#### **DECISION OF THE HISTORIC LANDMARKS COMMISSION**

**CLASS 3 MAJOR HISTORIC DESIGN REVIEW CASE NO.: HIS25-05**

**SUMMARY:** A proposal to install a rooftop solar array to the roof of 506 21st St NE.

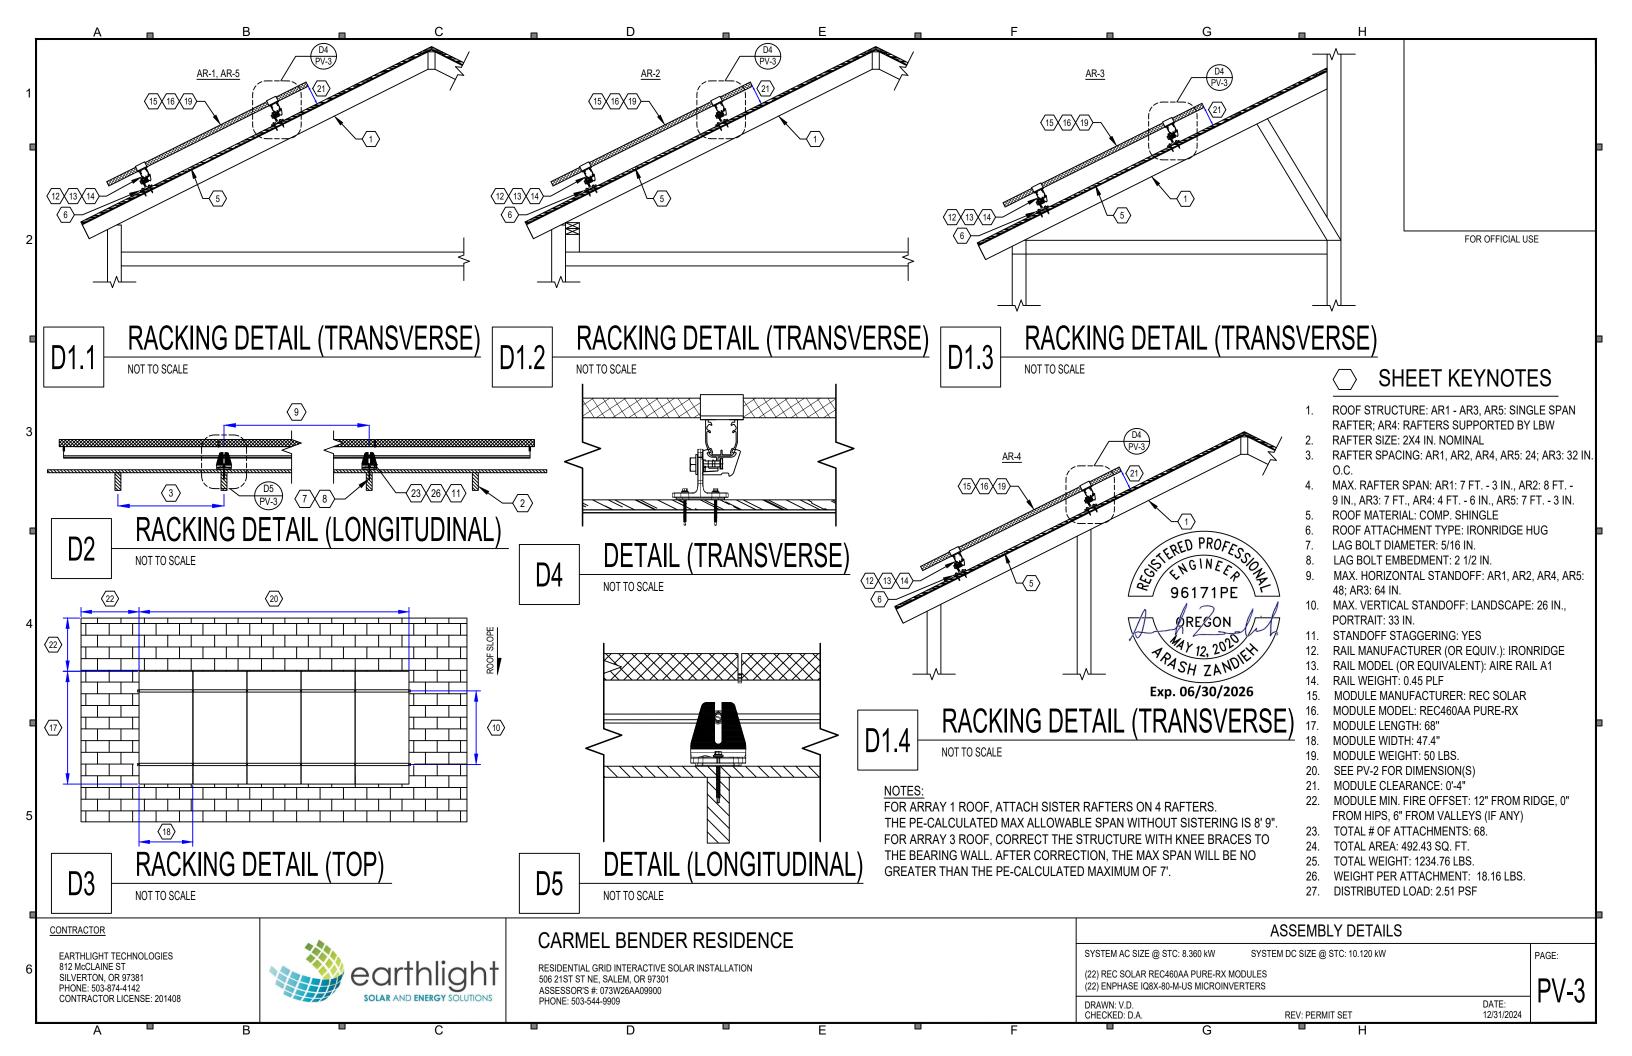
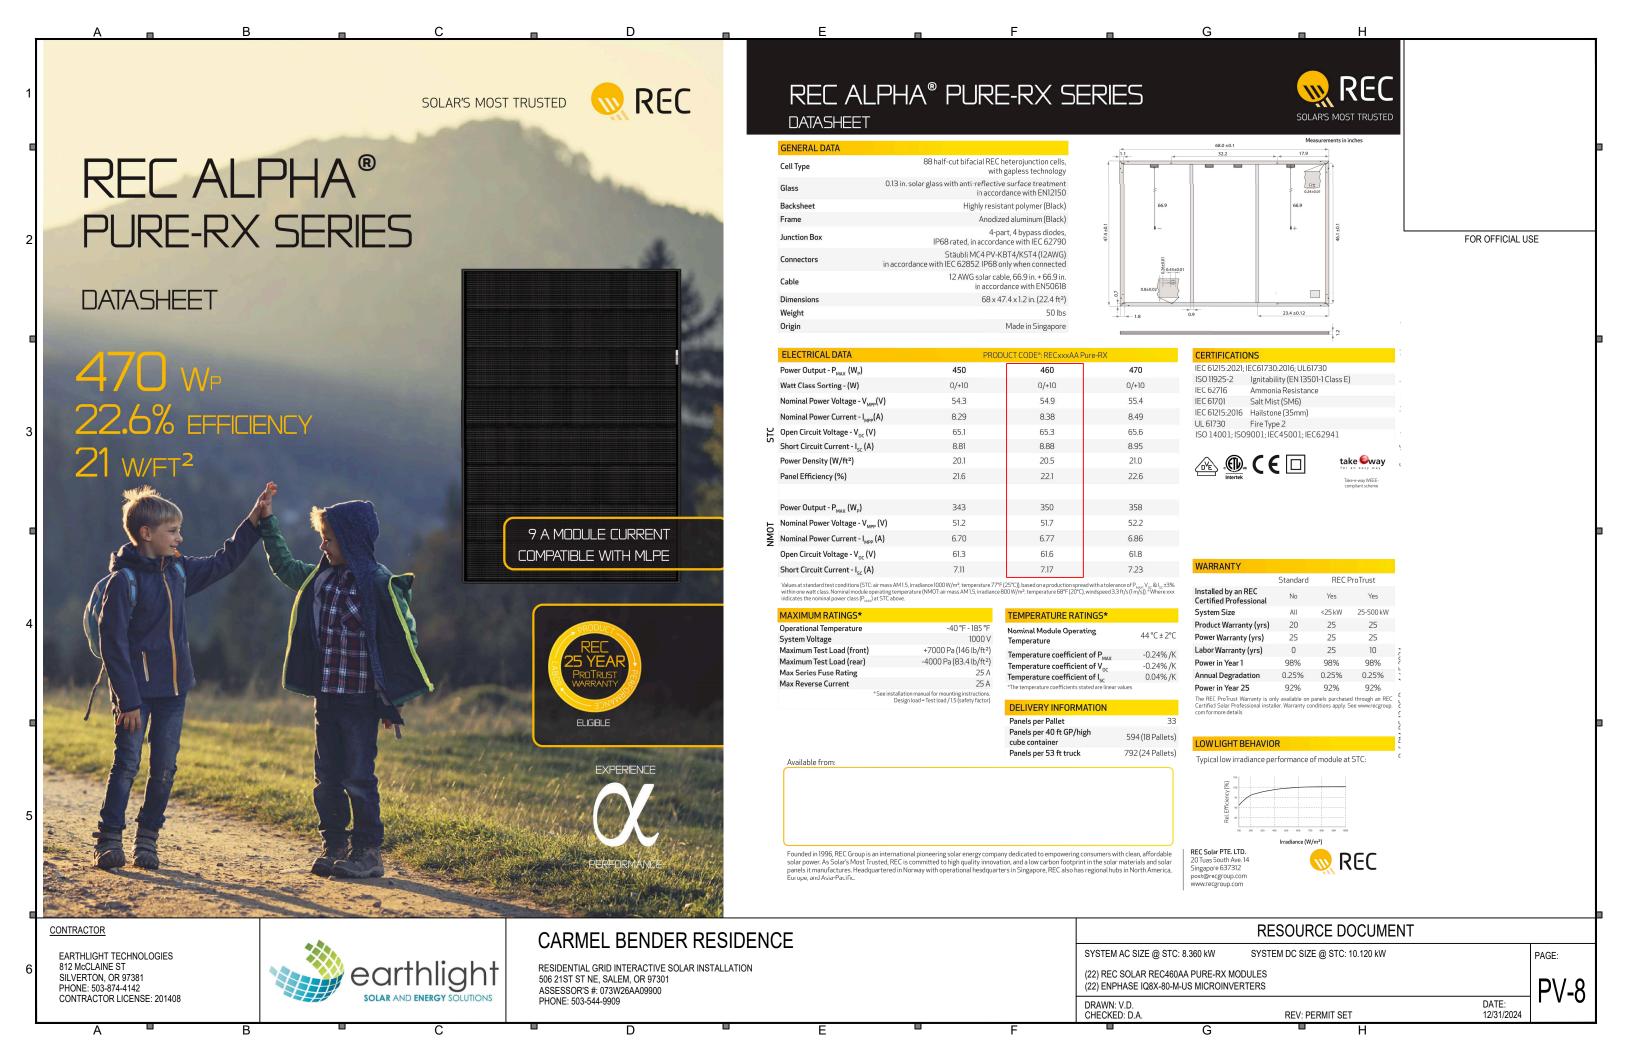
To minimize the visual impact, the solar modules are proposed to not be installed on the roof face that is plainly visible from the sidewalk at 21<sup>st</sup> & Breyman. The remainder of the roof surfaces are substantially not visible from the immediate property when alighting to the 21<sup>st</sup> St frontage.

The somewhat common approach, for properties subject to City of Salem Chapter 230, of restricting the energy improvements to the rear roofs is not feasible on this property. Due to the solar productivity thresholds that are required to qualify for solar incentives provided by Energy Trust of Oregon, solar modules must be placed on southerly-facing roofs with minimal shading. Furthermore, the homeowner will realize far greater financial and environmental benefits by having good sun exposure for the solar modules.

The modified design with 18 modules in 4-subarrays produces 10,863 kWh annually.
